CLAIREMONT COMMUNITY PLAN

Responses to the Clairemont Community Planning Group (CPG) comment letter provided on 10/9/25 relating to the Second Draft Clairemont CPU.

**Regarding: Second Draft Summer 2025 Clairemont Community Plan Update (CCPU)
Clairemont Community Planning Group Comments.**

Attachment 1
CCPG comments 10/9/25

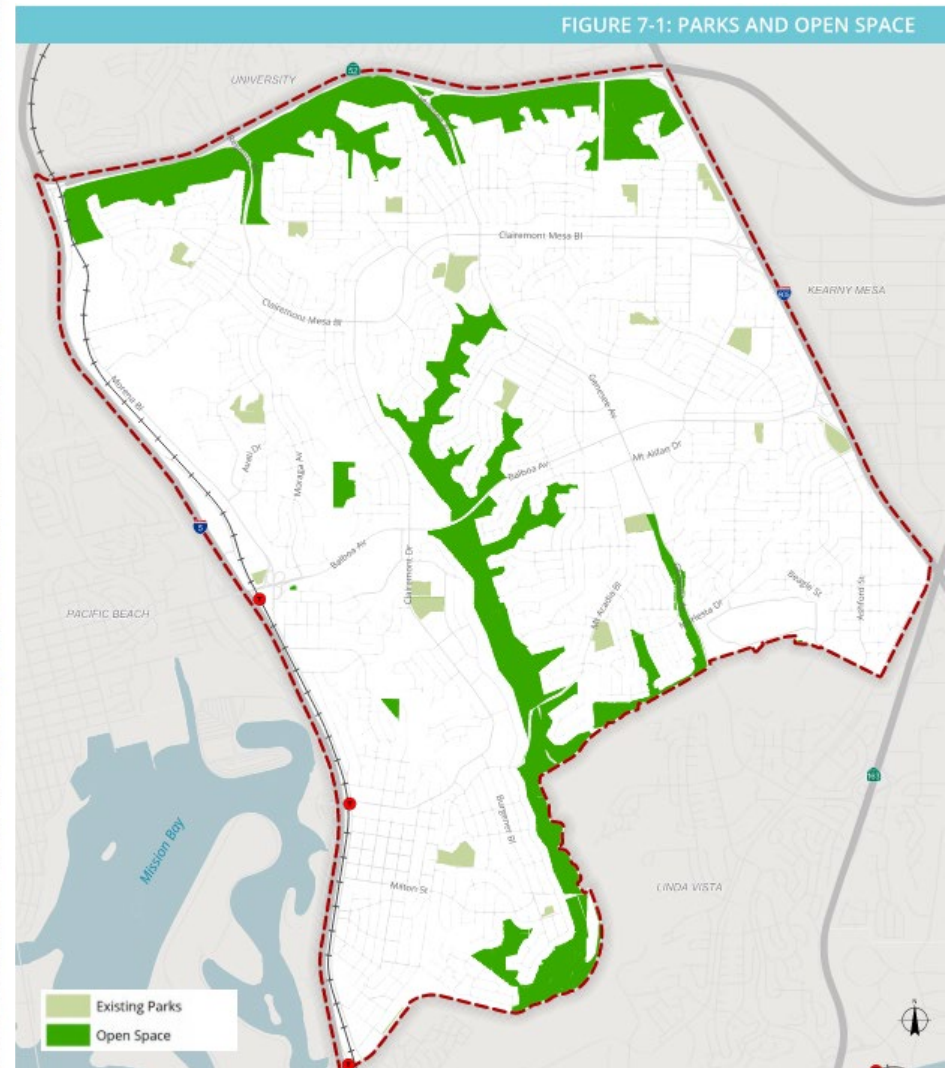
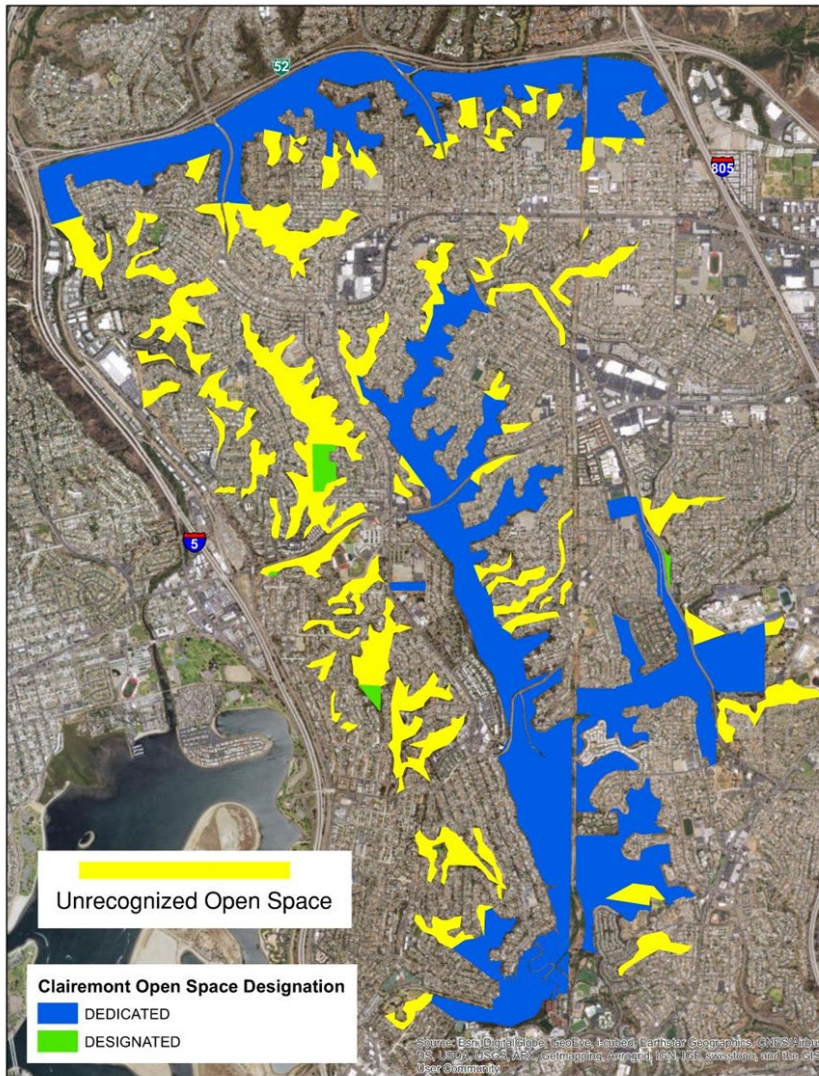
The majority of the canyons highlighted in yellow within the map at left are unprotected from development. We wish to protect them as much as possible

- a. Clairemont includes hundreds of acres of private canyons that provide significant quality of life and environmental benefits. Most of these private canyons are not recognized as open space and are mostly unprotected from development, see canyons highlighted in yellow (**see Attachment 1**).

- b. We request that the Planning Department explore and implement mechanisms within the CCPU to protect private canyonlands. Potential approaches could include re-zoning, Canyon Overlay Zones, canyon ridgeline development setbacks, or other appropriate tools.

Attachment 3
CCPG comments 10/9/25

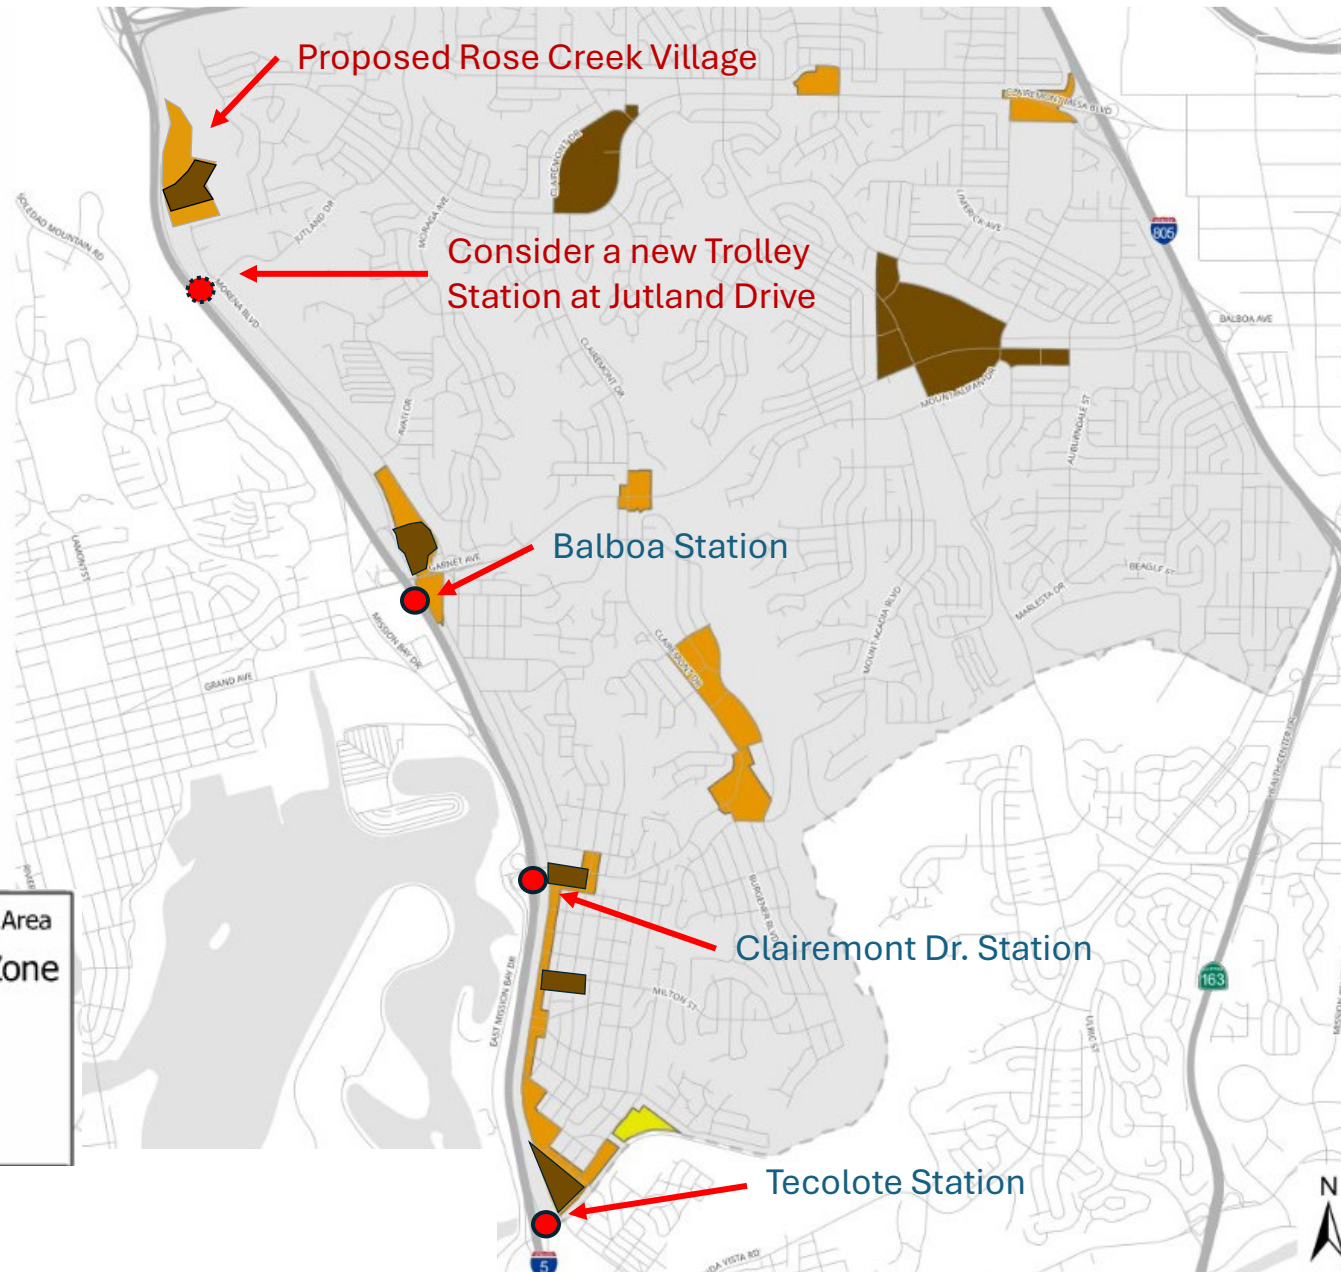
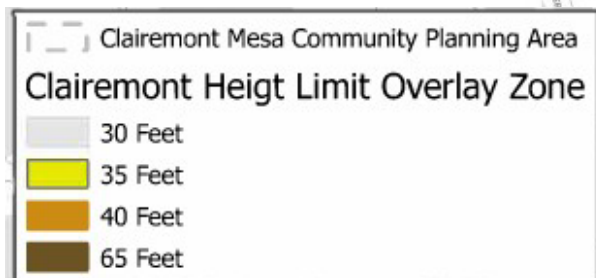
Additional housing proposed along the Blue Line: “Villages within the Village”

- Propose more housing and an employment center at / near the Rose Canyon Industrial Park with a partial increase in building height to 65 ft ht.
- Propose 65 ft. ht. in a portion of Rose Canyon Gateway site.
- Propose 65 ft and Plan density at Clairemont Dr., City Chevrolet, and South adjacent to Tecolote. Much of the remainder of Morena height to remain at 30 or 40 ft maximum.

- ii. Include density similar to the proposed plan density and heights along Morena Blvd from Clairemont Drive south to Tecolote. However, rather than a one size fits all “wall” along Morena Blvd., we suggest emphasizing higher density and taller development at key locations. This would likely accomplish more housing and create clusters of higher densities “Villages within the Village”. In addition to the Rose Creek North Village, three locations are suggested south of Clairemont Drive. **(See Attachment 3):**

- 1. The Bay View Plaza site (shovel ready) at the foot of Clairemont Drive.
 - 2. The “City Chevrolet” site that has recently changed ownership and is now vacant.

- 3. The triangular area at the far south end of Morena off Knoxville Street (that is planned to be connected to Morena). This would be near Tecolote Station and the large Tecolote Village just to the south in Linda Vista.

Attachment 5

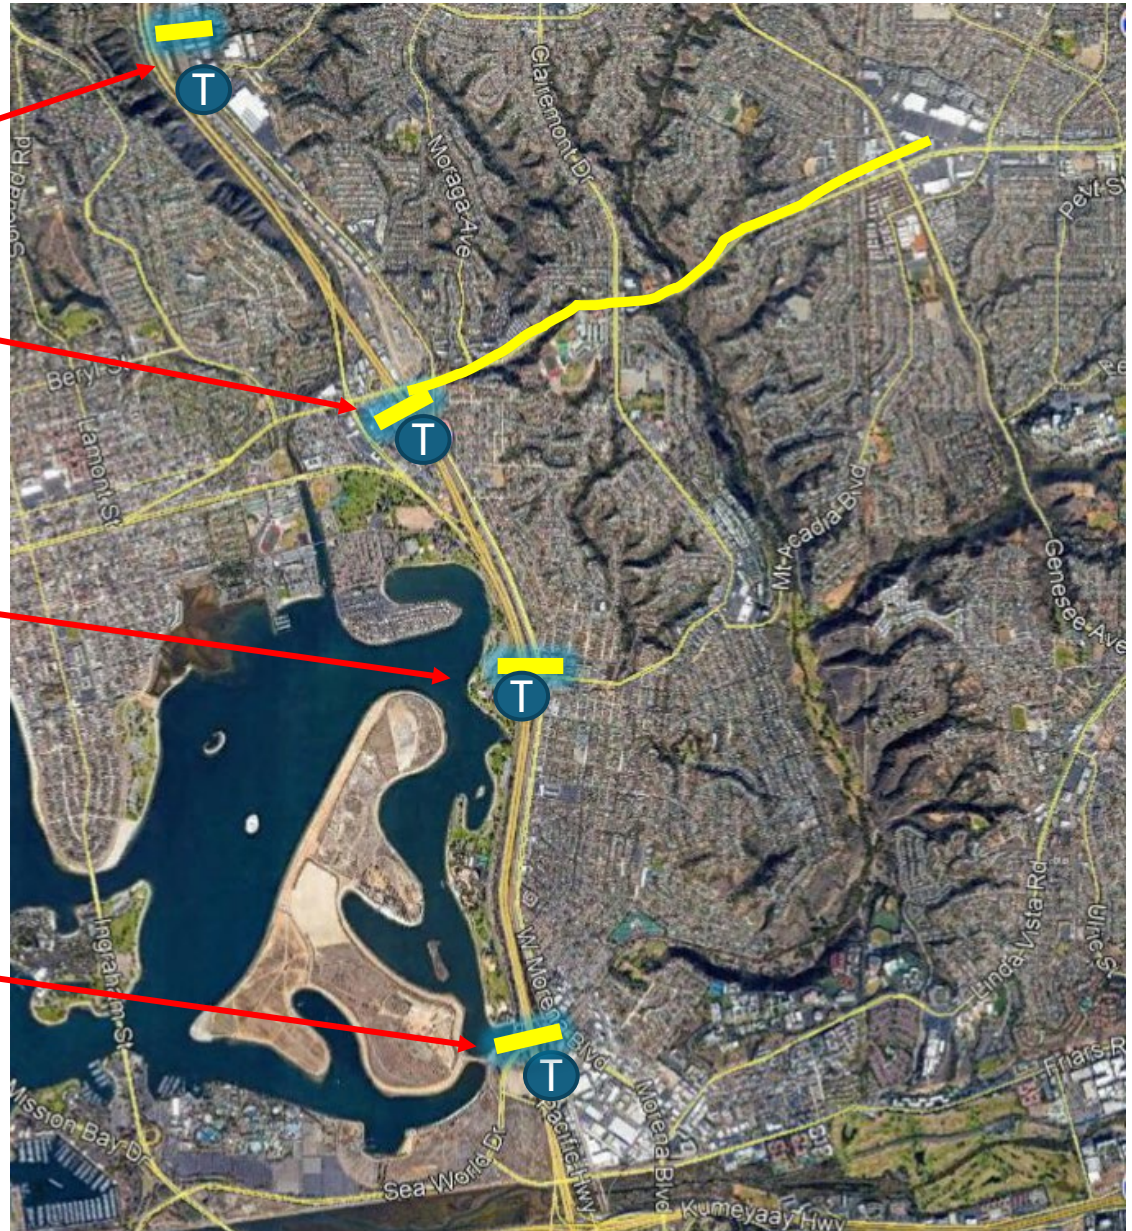
Community Connections to Stations and Beyond

Future light rail transit station at Jutland Drive with on-grade crossing to Santa Fe Street.

Aerial Tram from upzoned Community Core to the Balboa Station with access to Mission Bay.

Clairemont Drive Station with 150 parking spaces and improved bridge access to Mission Bay.

Tecolote Station with improved access to Tecolote Village to the South, Tecolote Canyon, and Mission Bay.

5. Add more robust and visionary community connections for pedestrians and bicyclists (See Attachment 5).

- b. We wish for the CCPU to be visionary and bold. The Aerial Trams from the Community Core Village to the Balboa Station and Mission Bay will create significant opportunities to efficiently move people between these transportation hubs.

- c. Each of the Trolley Stations along Morena Blvd. are hindered by unsafe and inconvenient access to Mission Bay. Please be more detailed and specific regarding improvements to Mission Bay access with modifications to existing bridges, addition of pedestrian bridges, the Tram, etc. These ideas are noted, but please illustrate them on the CCPU maps and graphics. Also, please review past studies. We are aware of a study by CR Engineers for Clairemont Drive, for example, which includes T– intersections and other measures to create a safer bridge there for pedestrians and bicyclists.

Attachment 6
CCPG comments 10/9/25

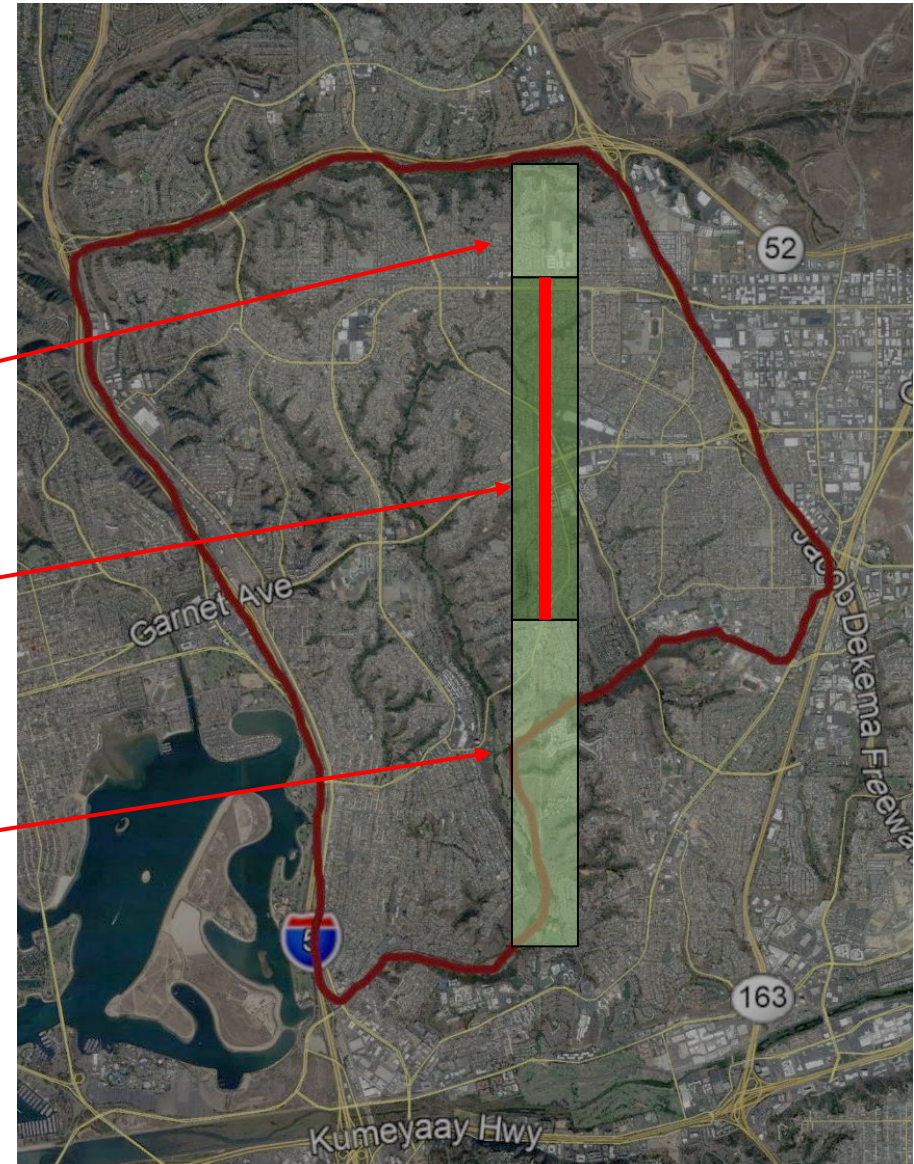
The “Green Spine”, an important recreation opportunity for the community

Trail to Marian Bear Park,
open to the public

Currently closed to the public. This
area could provide 41-acres of
passive recreation such as trails,
dog parks, community gardens, etc.
near the Community Core.

Tecolote Park Trail, open to the
public.

**SDGE power line easement through
Clairemont, Total of 4.5 miles x 150 ft wide.
Approx. 80 acres of open space total, currently
39-acres is open to the public.**

- i. The "Green Spine" open space within the SDG&E easement area is a very significant opportunity to provide passive recreation for the community. It is 150 feet wide and 4.5 miles long, totaling 80-acres. 39-acres in the north and south portions of the easement are open to the public for hiking and mountain biking. Unfortunately, 41-acres are

currently closed to the public through the urban areas of Clairemont, and near the Community Core Village. If opened to the public, this area could include trails, dog parks, community gardens, etc. Can the plan emphasize this opportunity in greater detail? SDG&E have been very resistant to the idea of opening up more of their easement and any additional emphasis within the plan would be appreciated. **(See Attachment 6)**
